**An Bord Pleanála Oral Hearing**

**Greater Dublin Drainage**

**Response to Roads Issues Raised on behalf of Gannon  
Properties and Response to Roads and Traffic Issues Raised  
by Sabrina Joyce Kemper**

***(27<sup>th</sup> March 2019)***

*Figure 1 Extract from Planning Drawing 32102902-2120 showing proposed WwTP access Road on the line of the indicative North-South Link Road provided by Fingal County Council*

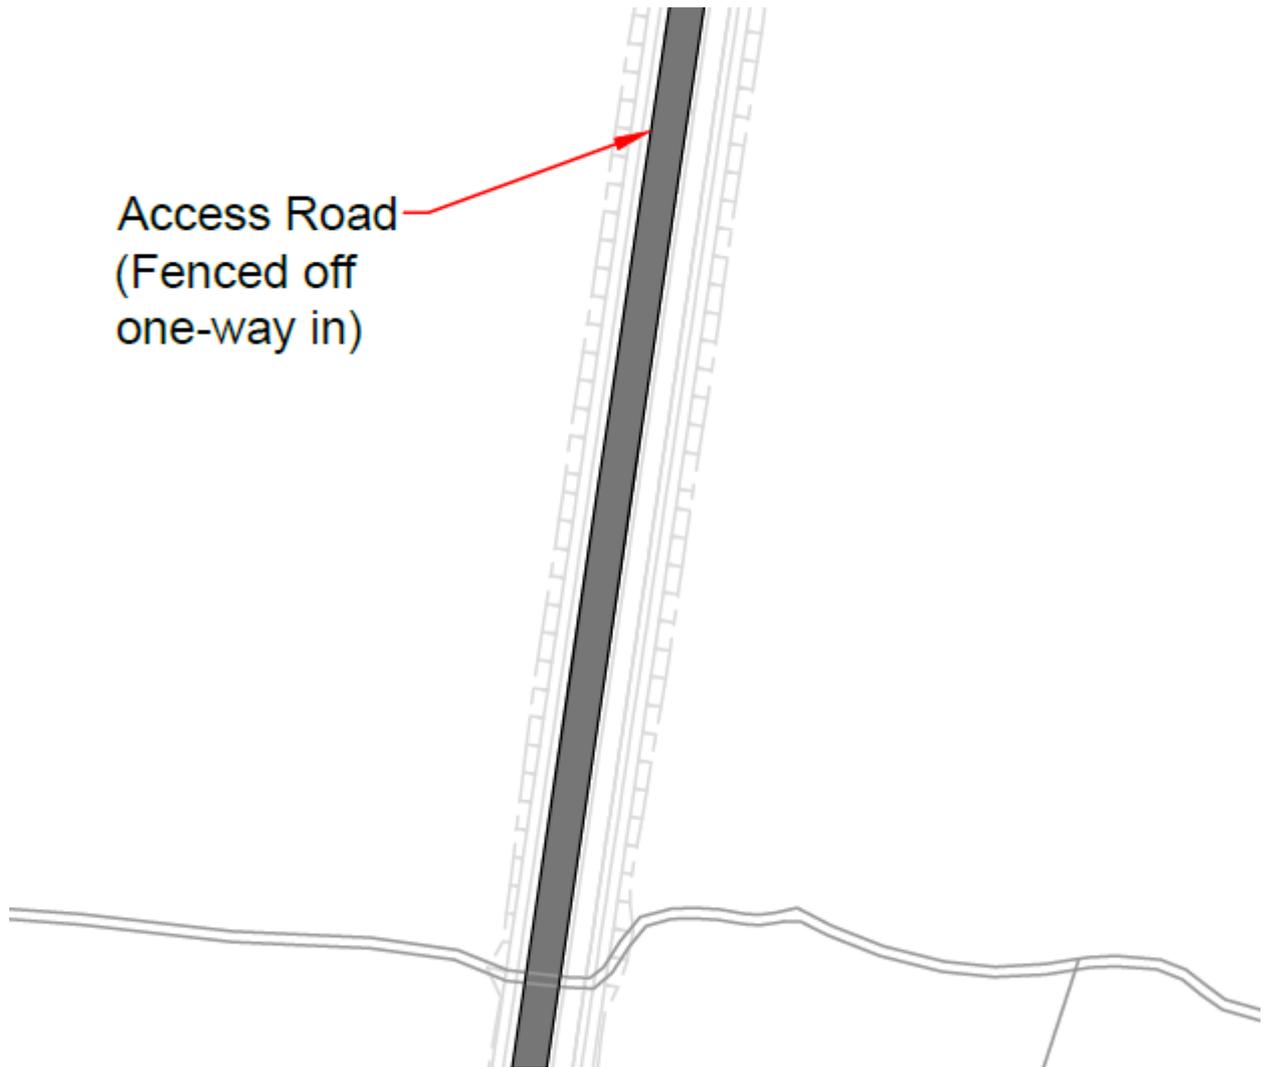
- 6 It is proposed that the western kerb line of the proposed access road be fixed along the kerb line of the outline North-South Link Road and construct a 5.0m wide carriageway to the east side, with a 2.0m wide footway to the west side of the kerb line. By following the line of the western kerb line, the construction of the proposed WwTP access road will not prejudice the FCC objective of the future North-South Link Road. If the North-South Link Road is developed over time, the proposed access road being fixed to the western kerb line, will ensure that the WwTP access can be maintained whilst road construction work to the east side of the access road can take place to construct the road cross section that will be determined by FCC as their plans for the area develop.

- 7 The design of the proposed WwTP access road is such that it will not prejudice the future link road. Road construction as shown on planning drawing 32102902-2205 shows a typical road construction comprising 250mm thick of bound materials (surface, binder and base layers) on a road foundation of 150mm thick layer of granular Clause 804 material on 180mm thick granular capping material. Should permission be granted for the development, the exact road design detail will be agree with Fingal County Council and Dublin City Council.

Figure 2 Extract from drawing 32102902-1067 showing extent of culvert.

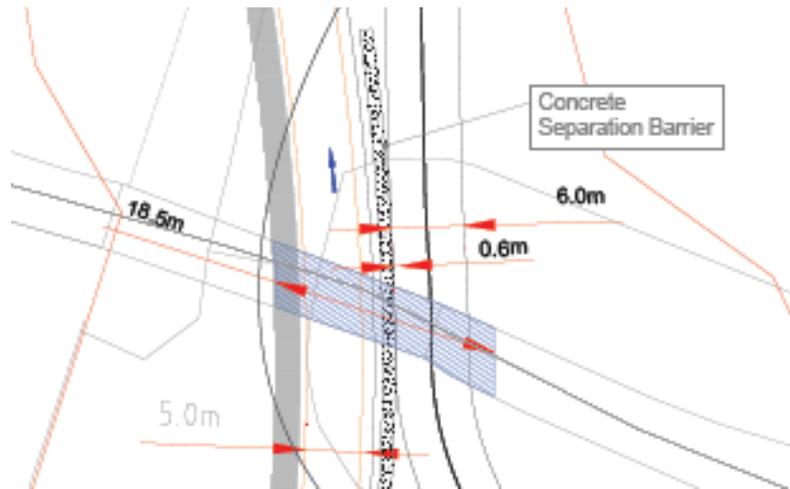
- 11 The observer has stated the applicant be conditioned to construct the Mayne River Culvert to the distributor road standard.
- 12 I can confirm that the application for the Proposed Development includes the construction of the Mayne River Culvert to facilitate both the proposed one-way WwTP Access Road and the adjacent Craobh Chiaráin GAA club access road proposals. This is shown as the blue hatched area on drawing 32102902-1067 included with Appendix 2 - Appendix A Part 2 of the Construction Environmental Management Plan.

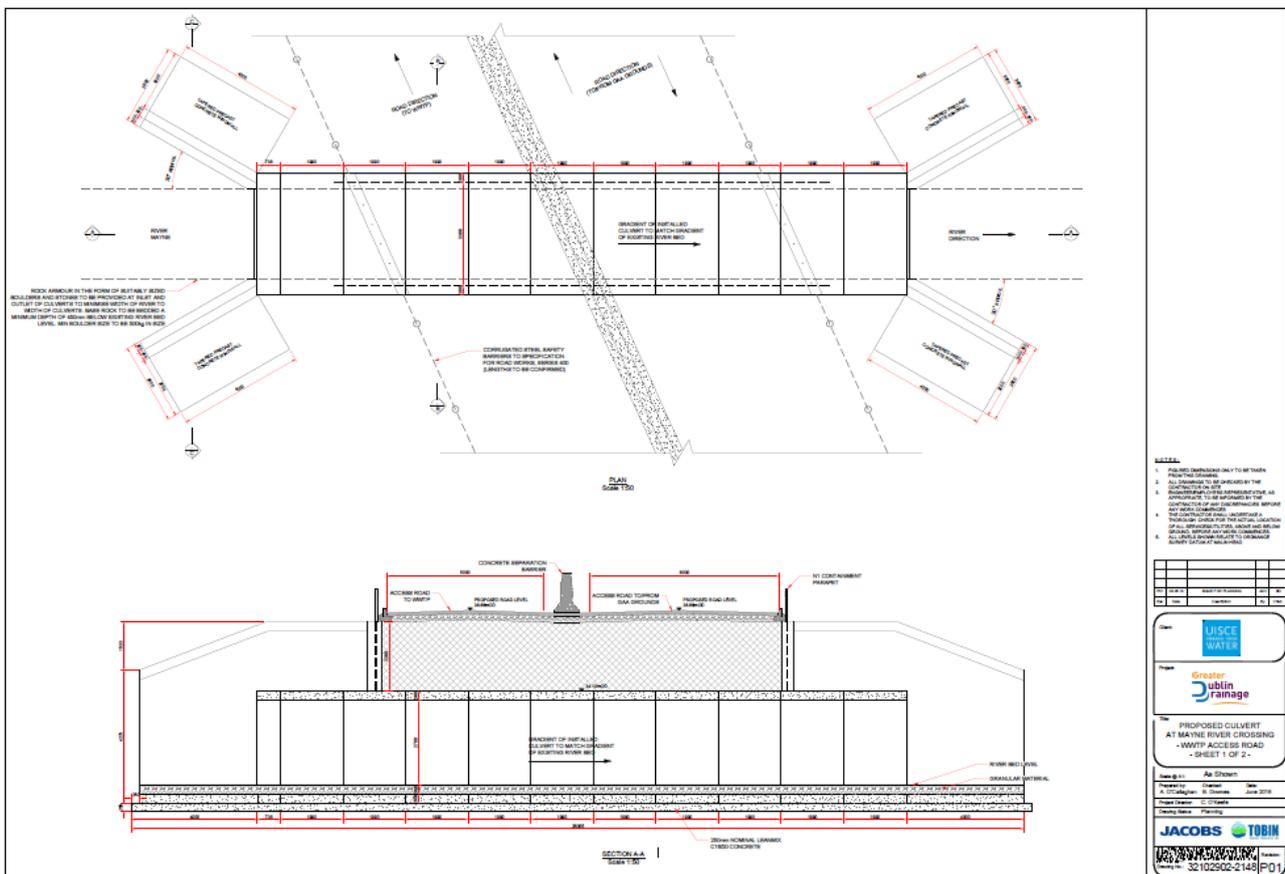
- 13 The length of the proposed Mayne River culvert shown on Planning Drawing 32102902-2148 will also facilitate the indicative cross section of the FCC future North South Link Road (i.e. 17.5m wide back of footway to back of footway, comprising 2m footway, 1.5m on road cycle lane, 3.5m northbound traffic lane, 3.5m reserve / turning lane, 3.5m southbound traffic lane, 1.5m cycle lane and 2.0m footway).
- 14 It is acknowledged that as the future North-South Link Road cross section is indicative, the future road width may be subject to change as the development plan is advanced. Should a wider future road cross section be required, the culvert can be widened by removing the eastern headwall and extending the culvert units the necessary additional width.
